# JONES & BEACH ENGINEERS INC.

**RE: Resubmission Letter for I.C. Reed Laydown Yard  
10 Scribner Road, Raymond, NH  
Tax Map 22, Lot 15  
JBE Project No. 20603**

Re: Opinion Letter for Aquifer Compliance Evaluation & Utility Pole BMPs  
10 Scribner Road, Raymond, New Hampshire.

## Site Plan with Test Pit Locations

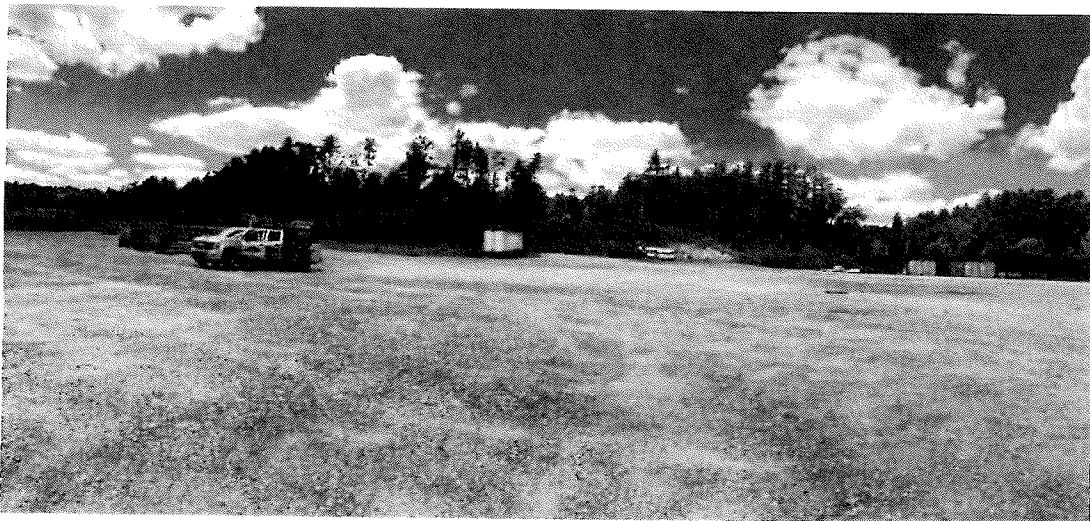
It is Verdantas' opinion that the proposed utility pole storage area should be shifted to the northwest part of the property where test pitting has shown that stratified drift materials are absent. Test pitting and site reconnaissance completed by Jones and Beach Engineers, Inc. (Jones and Beach) showed that western part of the Property has shallow bedrock with groundwater only being encountered on the eastern side at depths of approximately 60 inches below ground surface. Aquifer mapping completed by the U.S. Geological Survey (USGS) which formulates the basis for the Town's GPZ corroborates test pitting conclusions that aquifer conditions at the site are either thin or absent. Storing utility poles at this part of the property and staging the poles on concrete forms (Jersey Barriers) to keep them out of contact with soil and standing water should be sufficient to safeguard the aquifer from arsenic impacts. This letter summarizes test pitting activities and USGS mapping used to evaluate aquifer conditions. Further, the letter summarized our discussions with New Hampshire Department of Transportation (DOT), Eversource and the New Hampshire Department of Environmental Services (NHDES), regarding the appropriate best management practices regarding the storage of pressure treated utility poles.

DRAWING NO: **OV-1**  
 PROJECT: **LAYDOWN YARD**  
**10 SCRIBNER ROAD - RAYMOND, NH 03077**  
 CLIENT: **THE JONES & BEACH ENGINEERS, INC.**  
 P.O. BOX 888 RAYMOND, NH 03077 Ek 6186 PG 2270

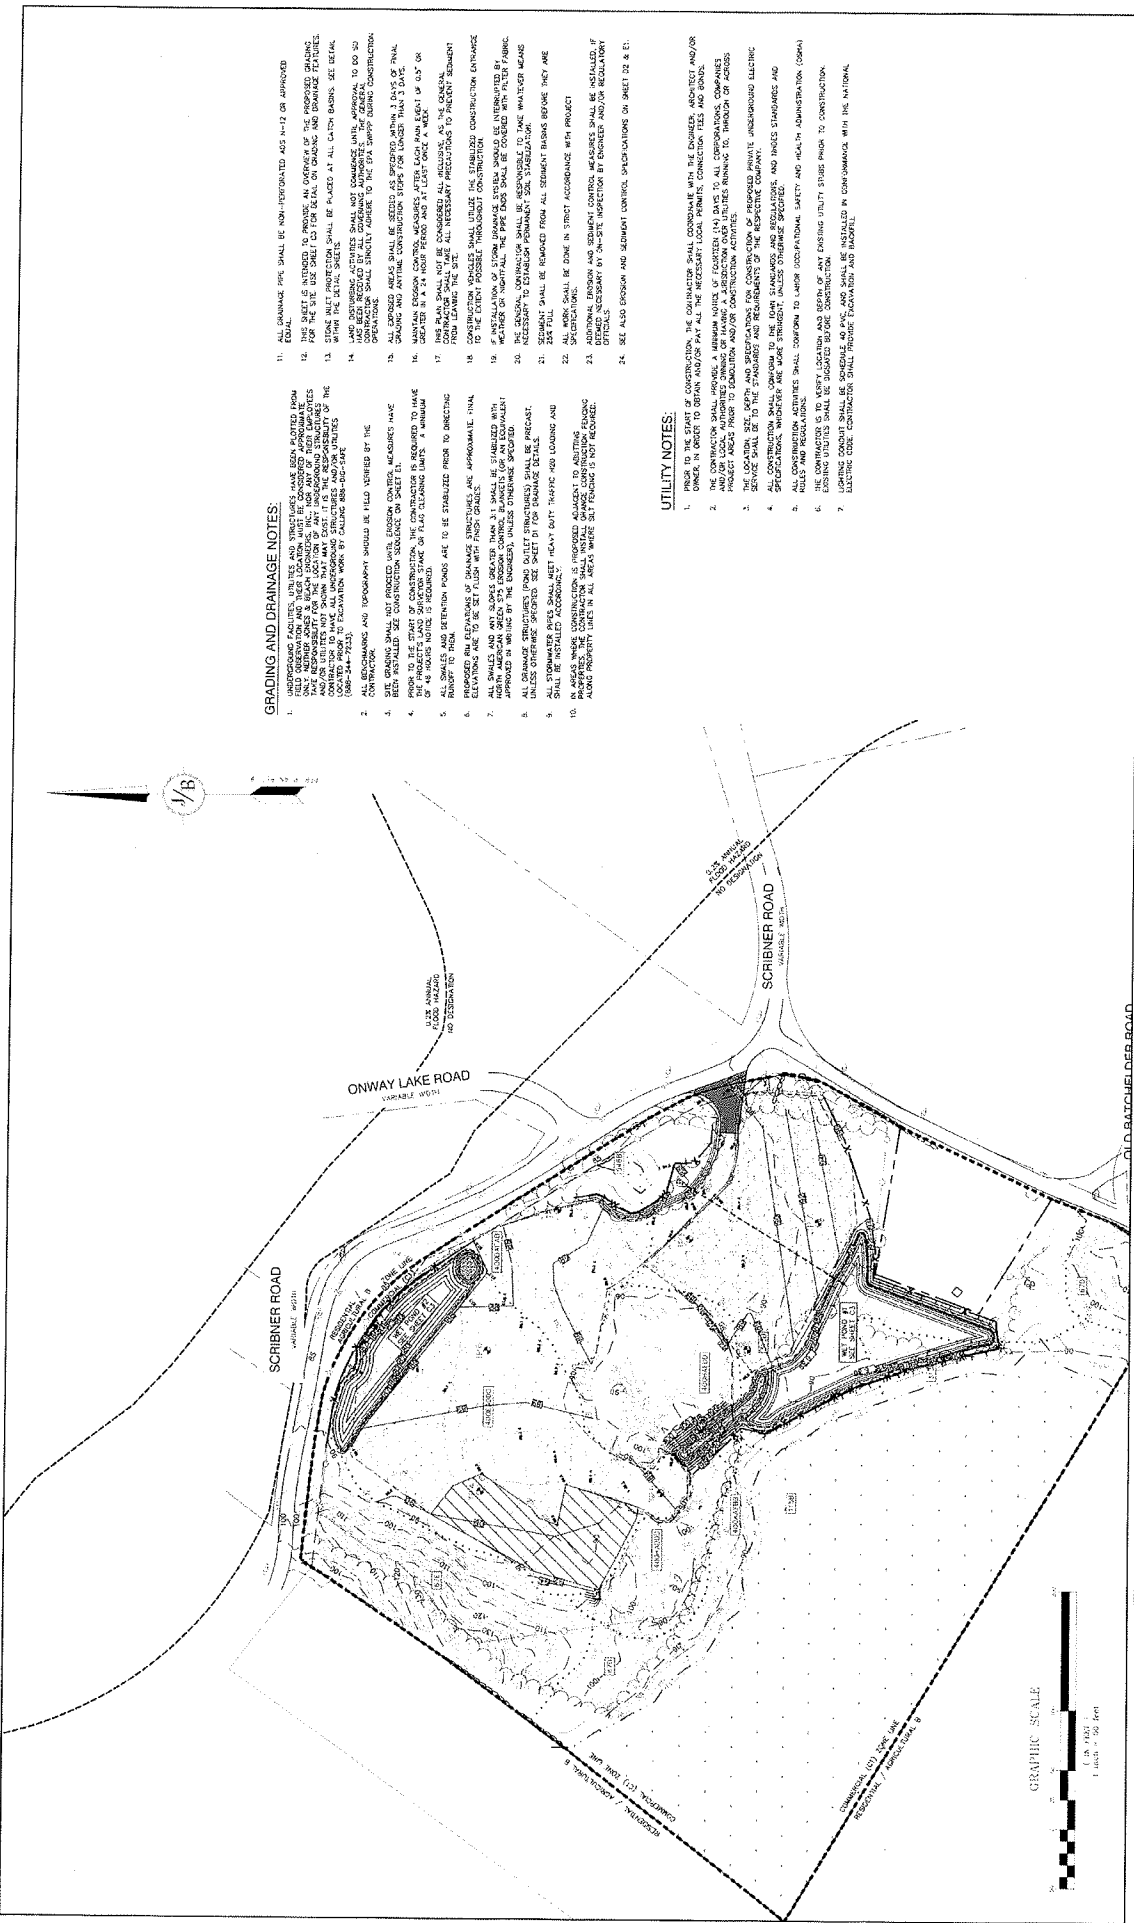
- In addition to these changes, minor drafting edits were made to the plan that do not affect the site design. One of these changes was the addition of an overview grading plan (OV-1).

DRAWING NO.  
**L2**  
 SHEET 7 OF 13  
 SEE W/2202 TO 2203

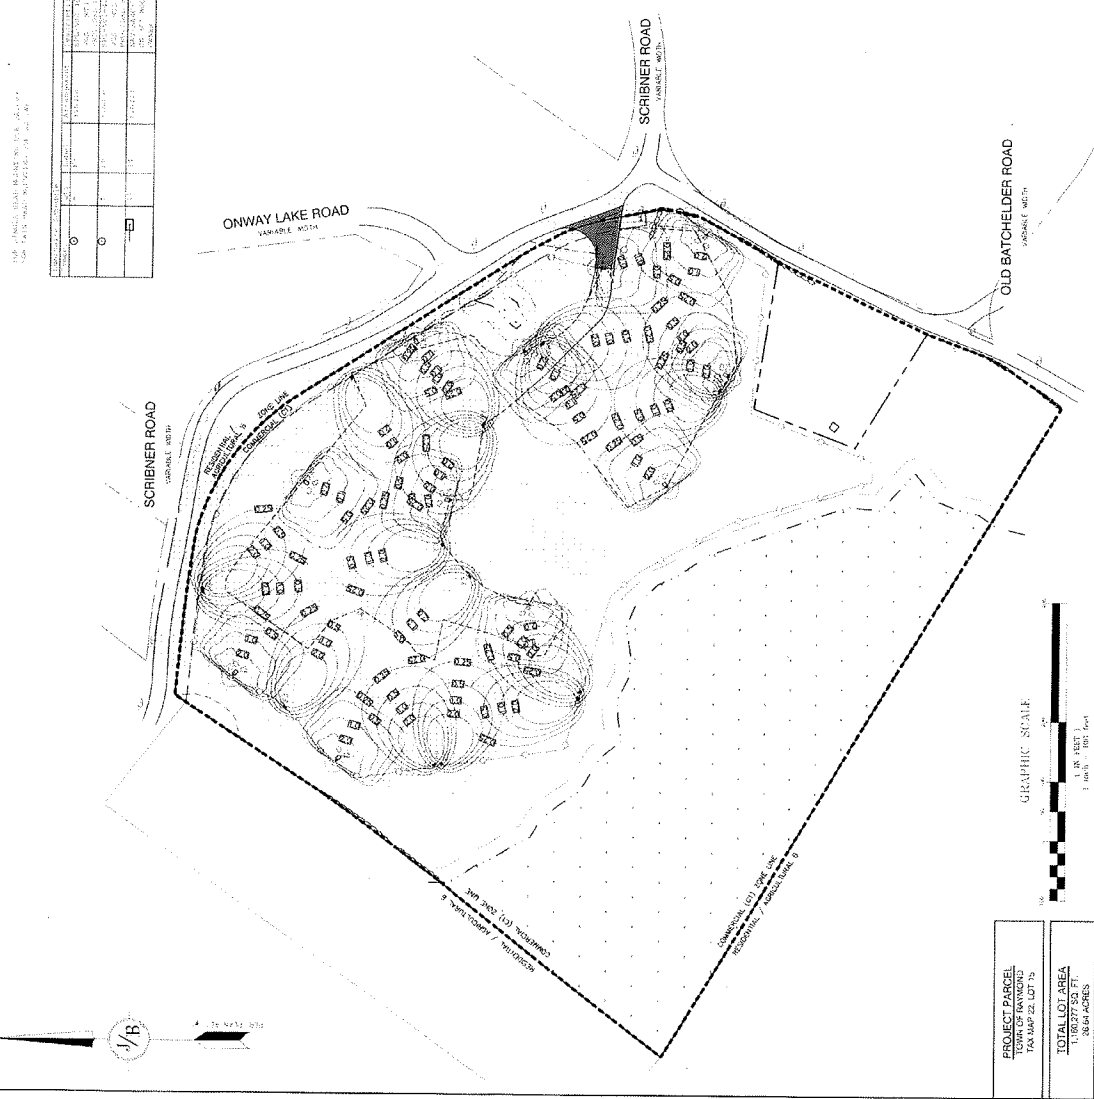
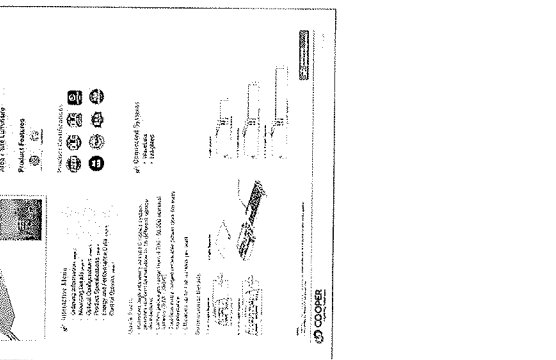
- One proposed light pole near the entrance to the site was shown to be causing spillover into the Scribner Road right of way. In order to correct this, the proposed light pole was pushed further back in to the site so that there would be no lighting trespass shown beyond any property lines. In addition to this, it was requested that the emergency lighting fixtures be changed to a 2-hour timer instead of a 4-hour timer. Note #4 on Sheet L2 has been revised to reflect this change. Otherwise, general drafting revisions were made to both lighting plans in order to improve the legibility of these plan sheets.
